Facility/Item: Sapaj Klean, Boynton Bch

RE: Response to Request for Additional Information Regarding Request for Modification of  
Hazardous Waste Operating Permit No. HO50-195905

RE: Request for modification of Hazardous Waste Operating Permit Ho 50-195905  
(Submitted on October 26, 1992).

Figure II.A.1(a)-7  
Truck Traffic Patterns and Loading/  
Unloading Areas of Hazardous Waste  
Safety-Kleen Corp. Facility  
Boynton Beach, Florida

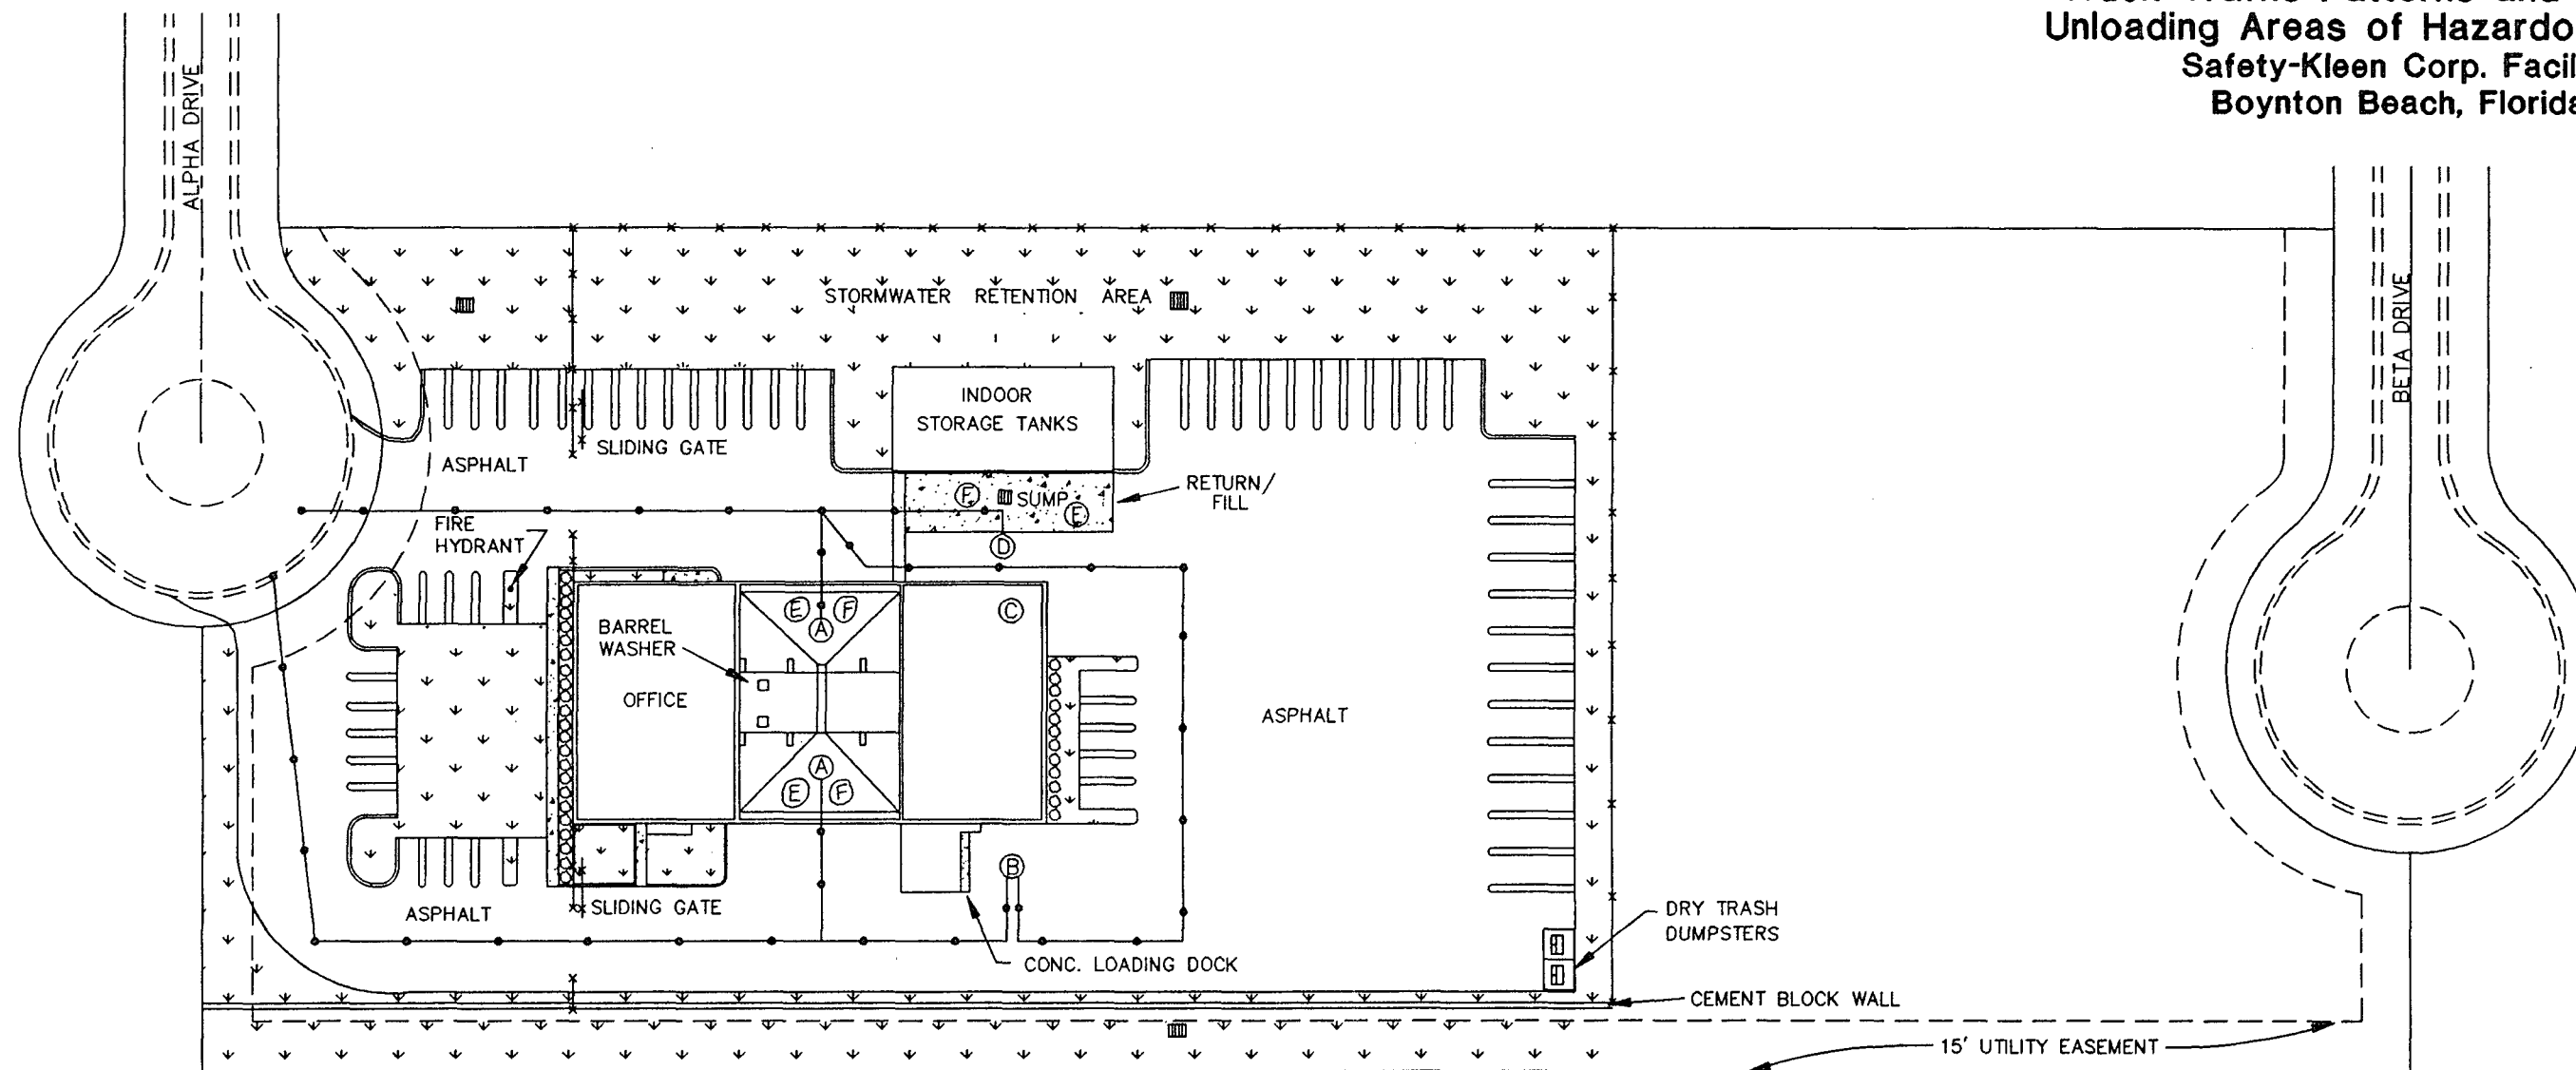
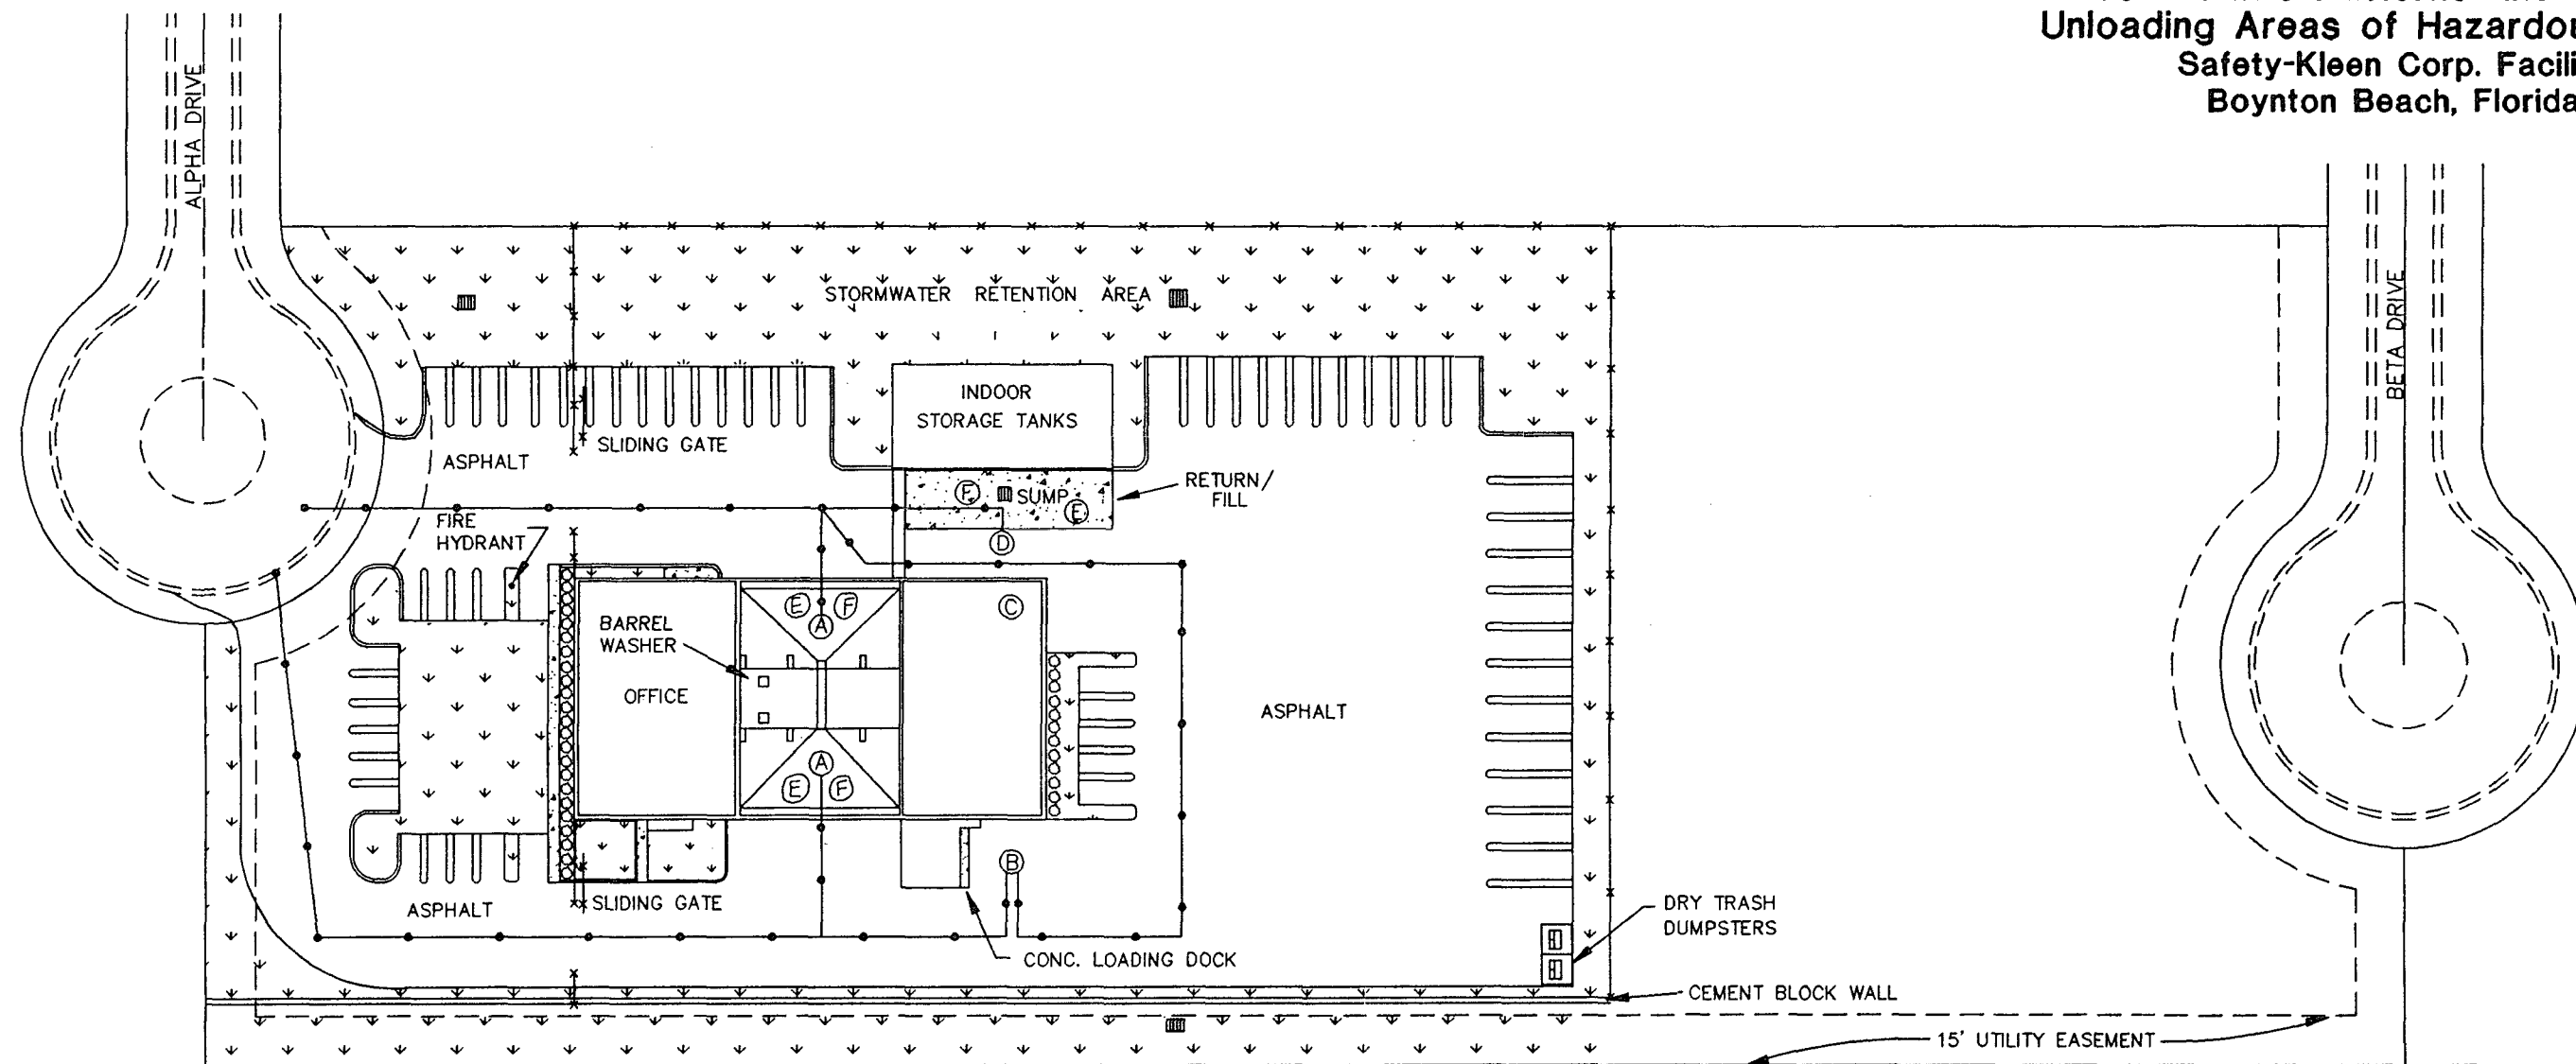
1. Safety-Kleen has requested that the permit include tanker truck to tanker truck transfer as an operating procedure. Safety-Kleen has provided a description and maps showing the location where the transfer may occur. The Department suggests that any truck to truck transfer of hazardous wastes should be conducted where secondary containment has been designed for such operations. The areas with appropriate secondary containment are shown in Figure II.A.1(c)-1. Either of the areas labeled "A" or that area labeled "D" would provide the containment necessary to prevent an accidental release from escaping to soils surrounding the facility. The transfer areas (Area E and Area F) proposed in Attachment I.B.3 do not take advantage of the safety features inherent to the facility's design. An accidental release could flow off of the asphalt and on to surrounding soils or flow down into the storm drain (not shown in Figure II.A.1(c)-1). Please submit a management procedure for truck to truck transfer which takes advantage of the containment systems designed and currently used at the facility for similar hazardous waste management activities.

The first item was with regard to the tanker-truck-to-tanker-truck transfer operations. SK has no objections to the agency's request to perform these functions within areas where secondary containment is available. The appropriate portions of the text and figures have been revised to indicate that tanker-truck-to-tanker-truck transfers will occur within the truck unloading area on the north side of the building. This area is sloped to a sump which provides secondary containment.

NOTE: E & F OCCURS ON THE TRUCK PAD  
NORTH OF THE WAREHOUSE
